**METROPOLITAN DEVELOPMENT COMMISSION  
HEARING EXAMINER**

**Case Number:** 2024-CVR-855 / 2024-CPL-855

**Property Address:** 1527 East 12th Street (Approximate Address)

**Request:** Variance of development standards of the Consolidated Zoning and Subdivision Ordinance to build within 60 feet of the stream protection corridor (not permitted).  
Approval of a Subdivision Plat to be known as Replat of Lot 29 in Milligan's Park Lane Addition, subdividing 1.878 acres into three lots.

Figure 1 Original Site Plan 12.10.2024

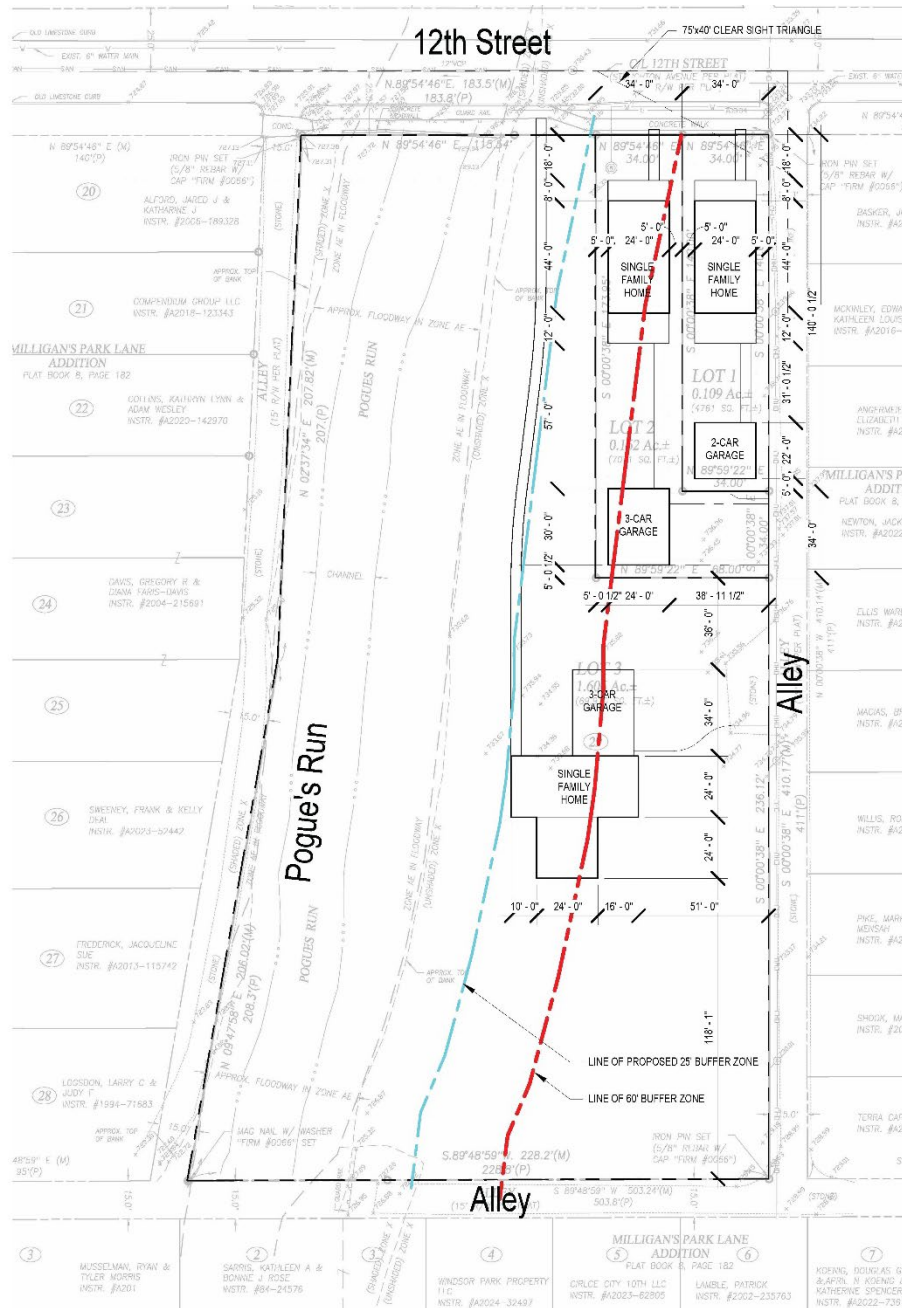
Staff recommends **denial** of the intrusion into the Stream Protection Corridor. The function of the Stream Protection Corridor is to control erosion, improve water quality, provide flood storage, and preserve habitat and aesthetics. No hardship exists as the petitioner can still reasonably develop the property without encroachment, as demonstrated in Petitioner's Exhibit B, without the granting of this variance.

Figure 2 New Site Plan 5.1.2024

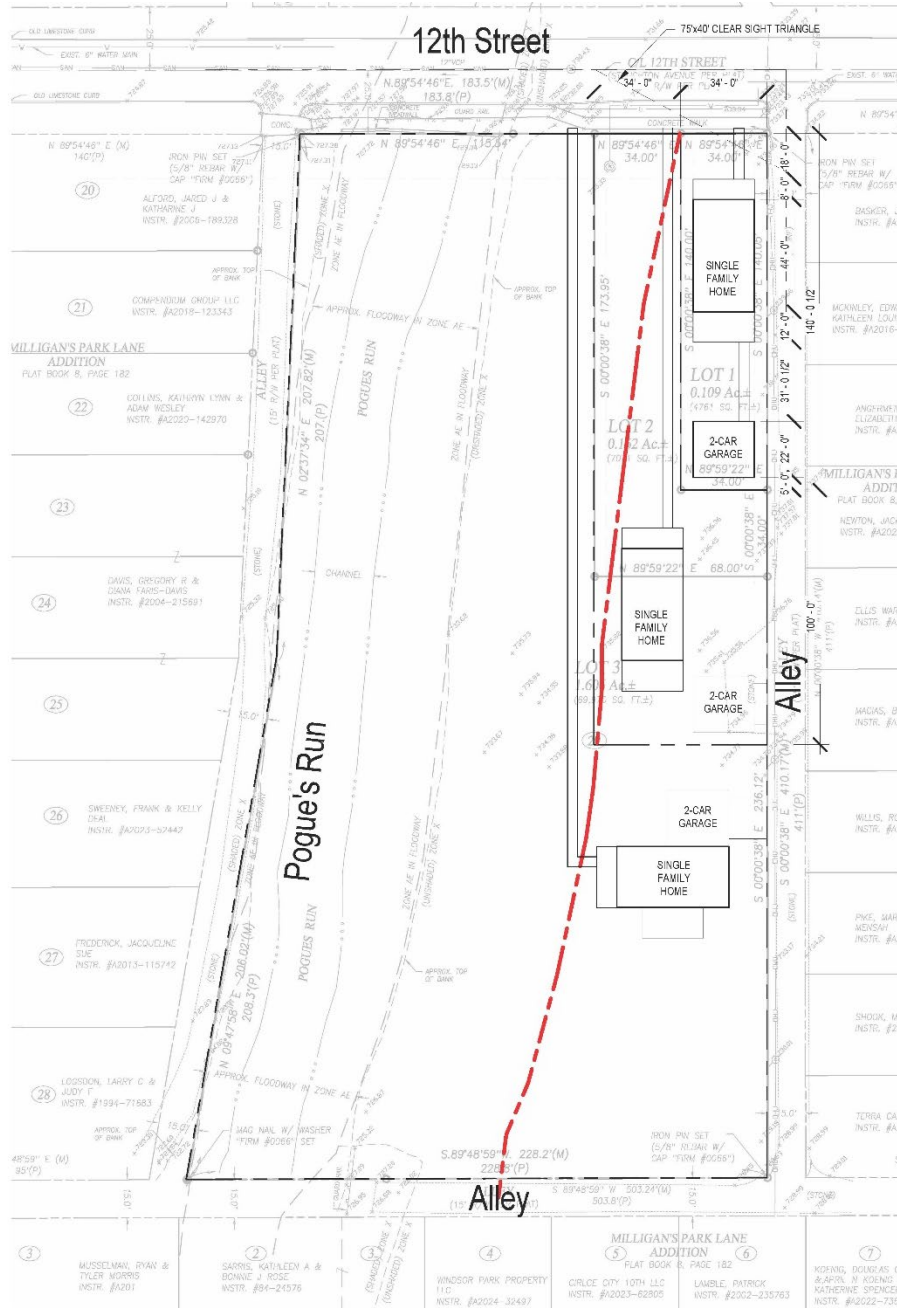
The petitioner submitted an amended site plan, which includes a 25-foot buffer from Pogue's Run, based on the soil report from Marion County Soil & Water Conservation District. However, staff believes the current site plan does not demonstrate practical difficulty. Alternative configurations of the site plan exist that would allow development while complying with the stream protection corridor, thus the hardship criteria cannot be satisfied.

Therefore, staff still **recommends denial** of the variance of development standards request to build within 60 feet of the stream protection corridor.
